Subject: AP1000 COL Response to Request for Additional Information (TR 29)

Westinghouse is submitting a revised response to the NRC request for additional information (RAI) on AP1000 Standard Combined License Technical Report (TR) 29, APP-GW-GLR-044, Nuclear Island Basemat and Foundation. This RAI response is submitted in support of the AP1000 Design Certification Amendment Application (Docket No. 52-006). The information included in the response is generic and is expected to apply to all COL applications referencing the AP1000 Design Certification and the AP1000 Design Certification Amendment Application.

RAI Response Number: RAI-TR29-SRSB-01
Revision: 1

Figure 6-43
2-Inch Cold Leg Break, ADS 1-3 Integrated Vapor Discharge

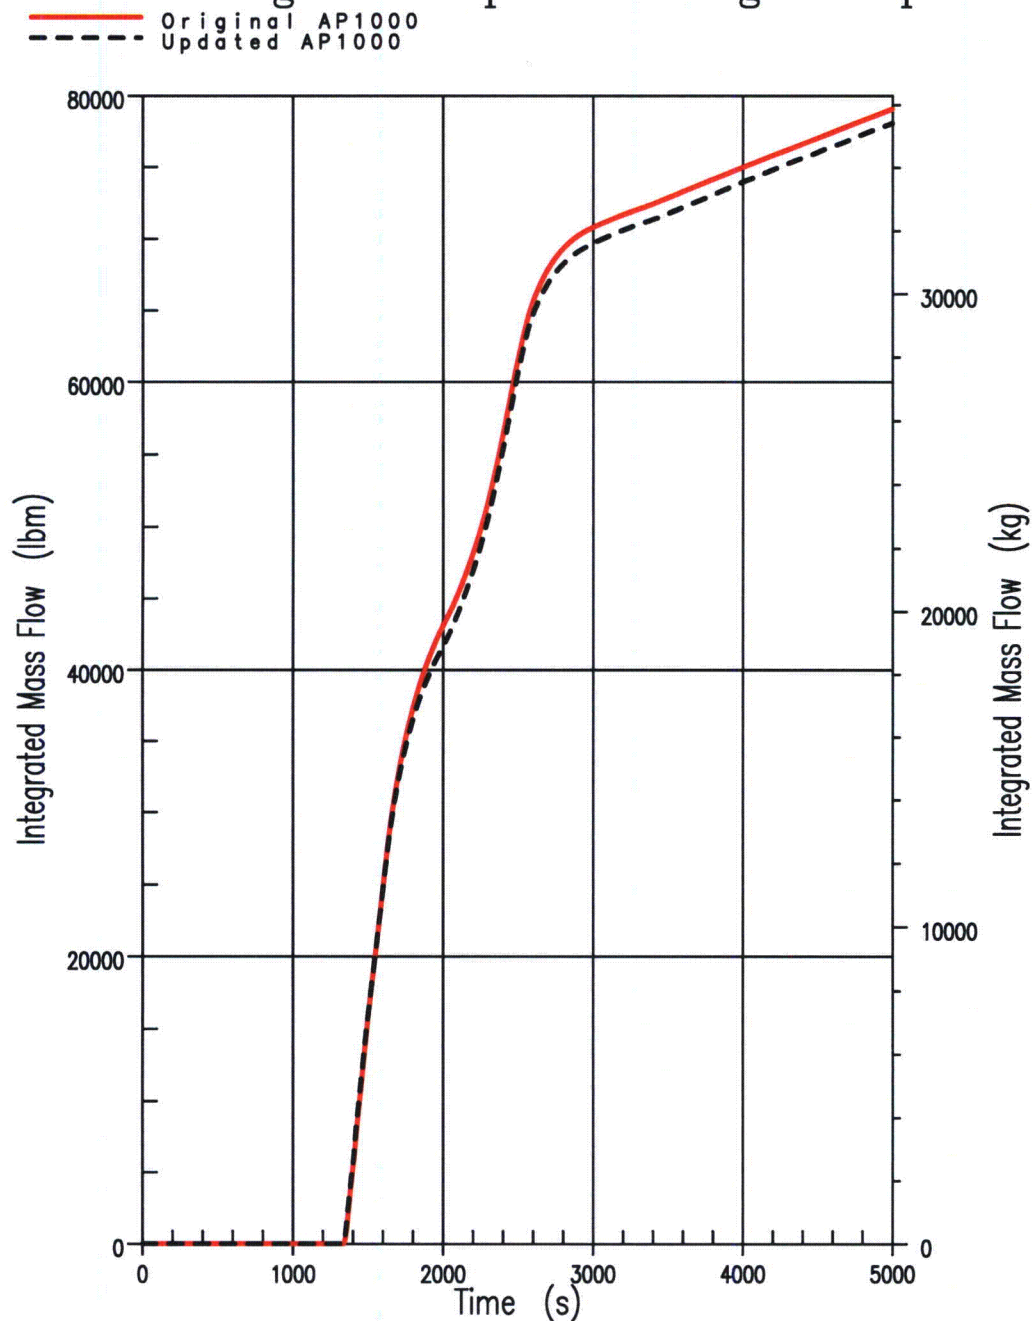
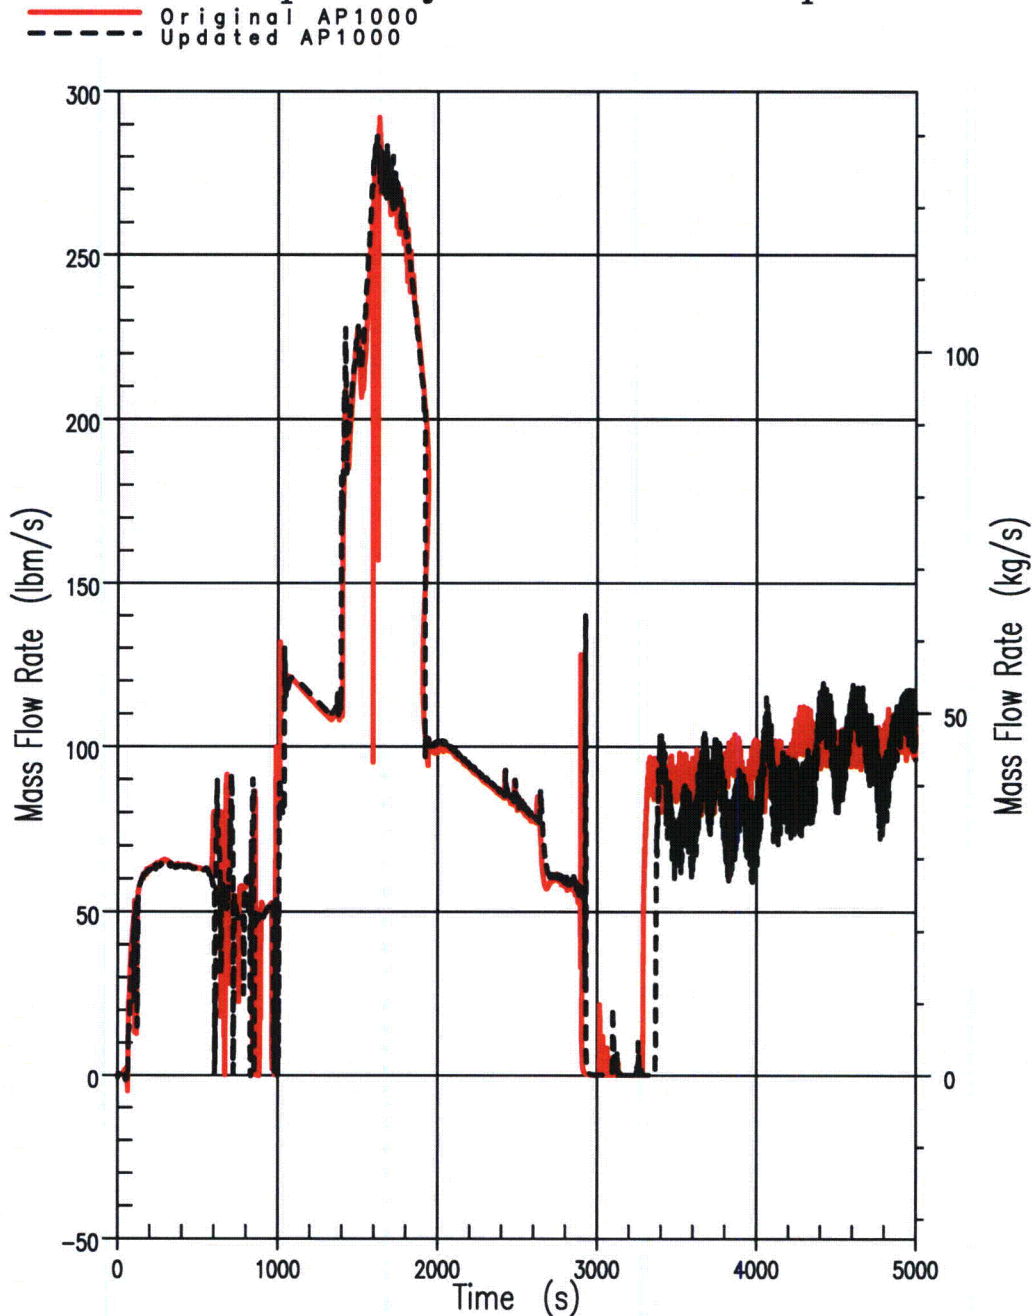
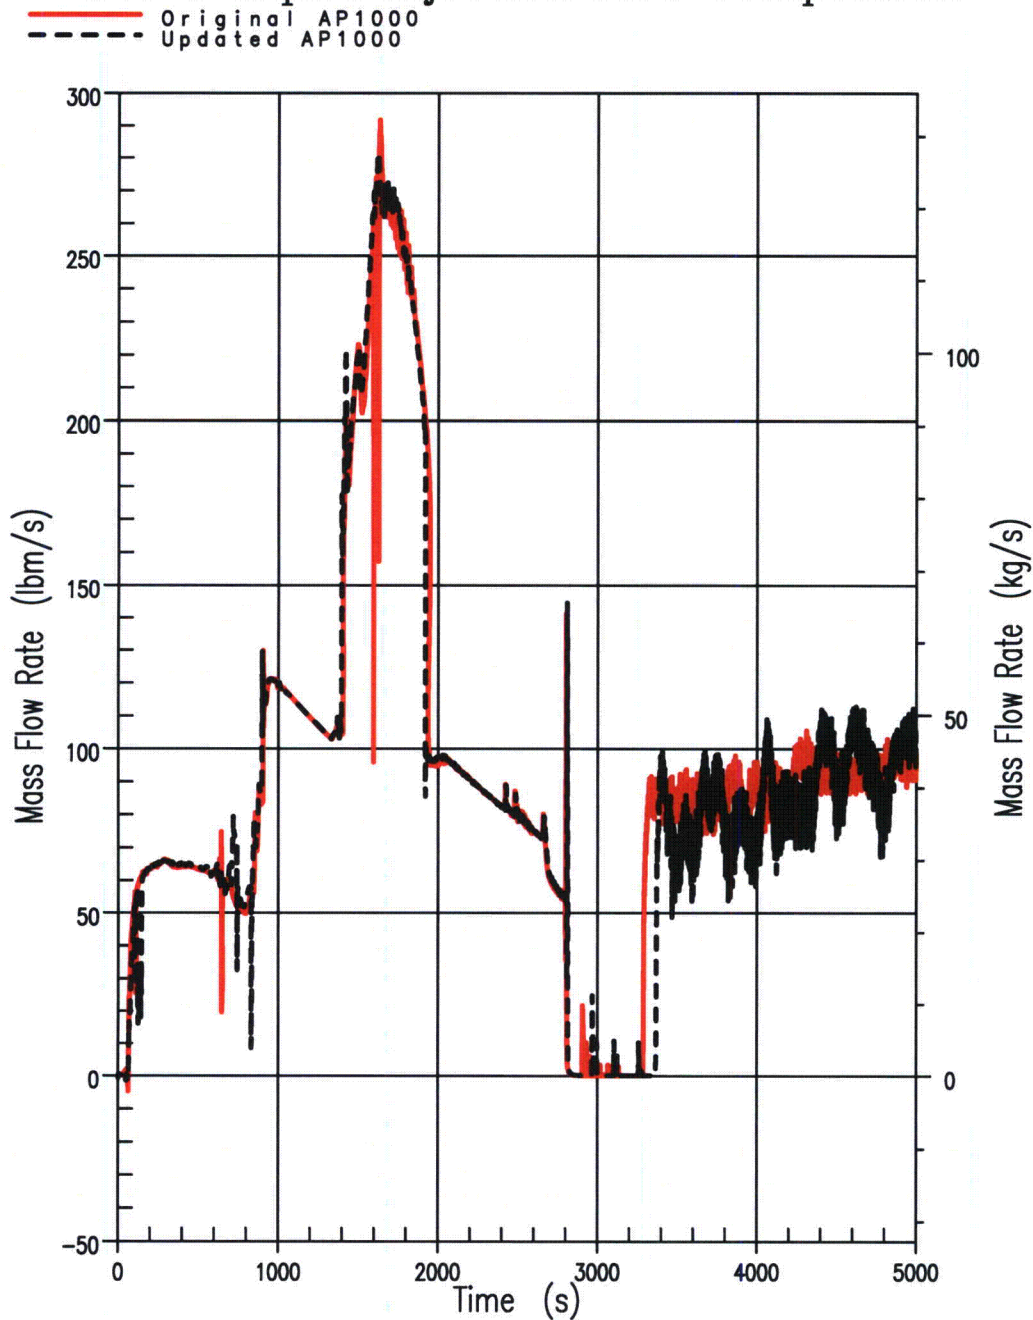
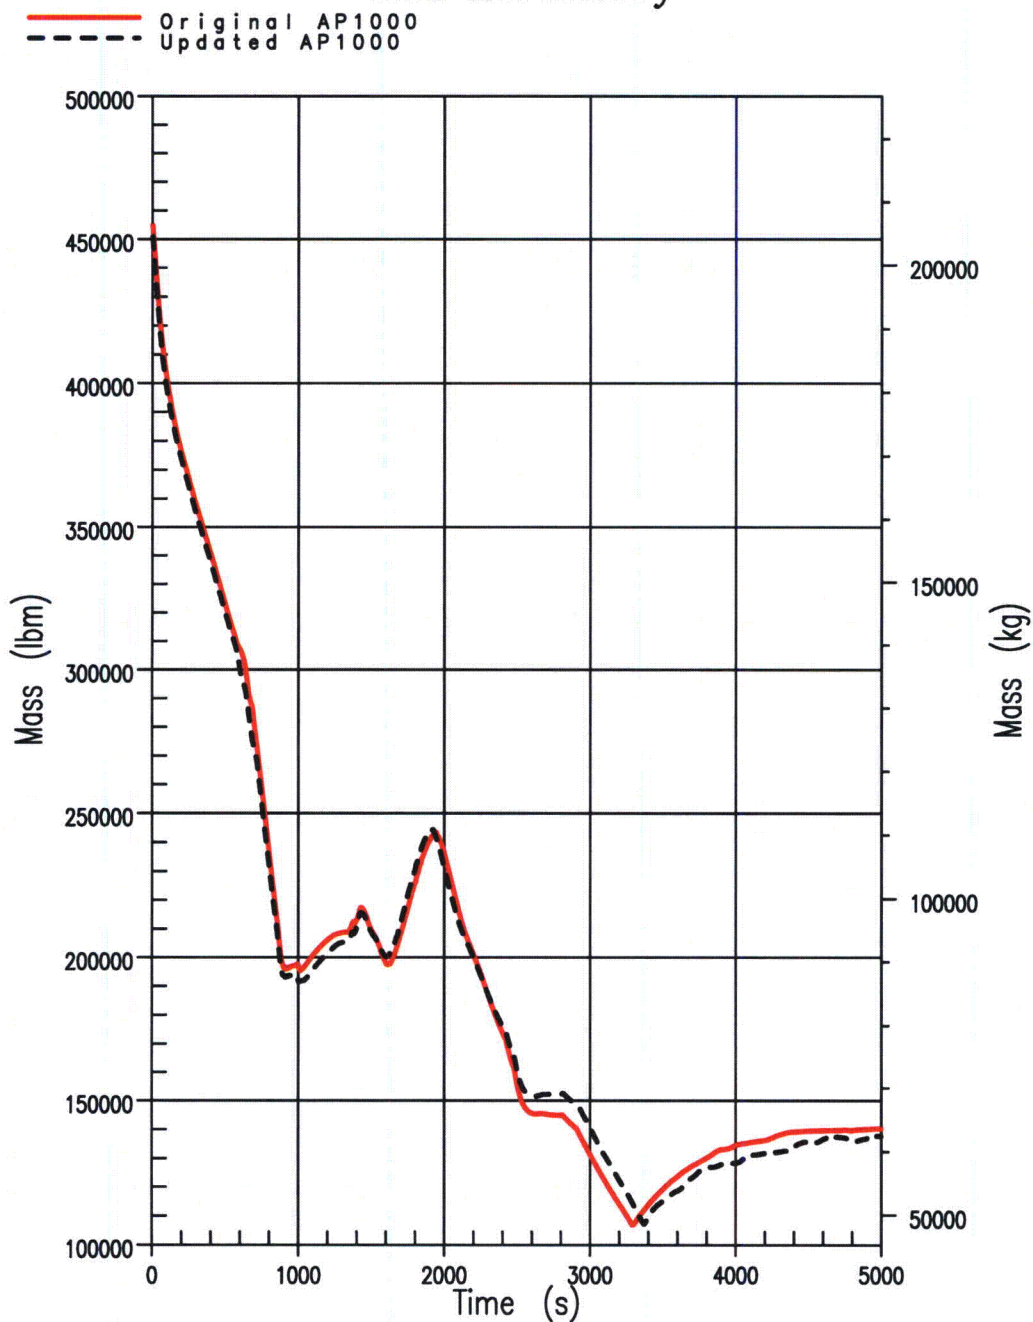
Please provide an evaluation of the impacts of these proposed changes on the analysis results of each of the transients and accidents in DCD Chapter 15. The evaluation should demonstrate either the analysis results of DCD Chapter 15, Revision 15, remain bounding and valid, or the effects of these changes are insignificantly small that the applicable acceptance criteria for these transients and accidents remain complied with.

Table 6-3 and Figures 6-37 through 6-46 present a comparison of the 2-Inch Cold Leg break simulations. The results again demonstrate the effect of the change in the reactor internals design (including the revised Pressurizer). Decreases in both the Pressurizer Mixture Level (Figure 6-40) and Pressurizer Void Fraction (Figure 6-41) were observed as a result of the Pressurizer change. For the 2-Inch Cold Leg Break, this subsequently reduces both the Automatic Depressurization System (ADS) Stage 1-3 liquid discharge (Figure 6-42) and ADS 1-3 vapor discharge (Figure 6-43). The overall effect of these design changes is slight variations in the Reactor Coolant System (RCS) inventory over the transient simulation period (Figure 6-46) with about the same predicted minimum RCS inventory. No significant changes in the RCS Pressure (Figures 6-37 and 6-38), Core Mixture Level (Figure 6-39), and DVI injection characteristics (Figures 6-44 and 6-45) are observed as a result of the design change implementation.
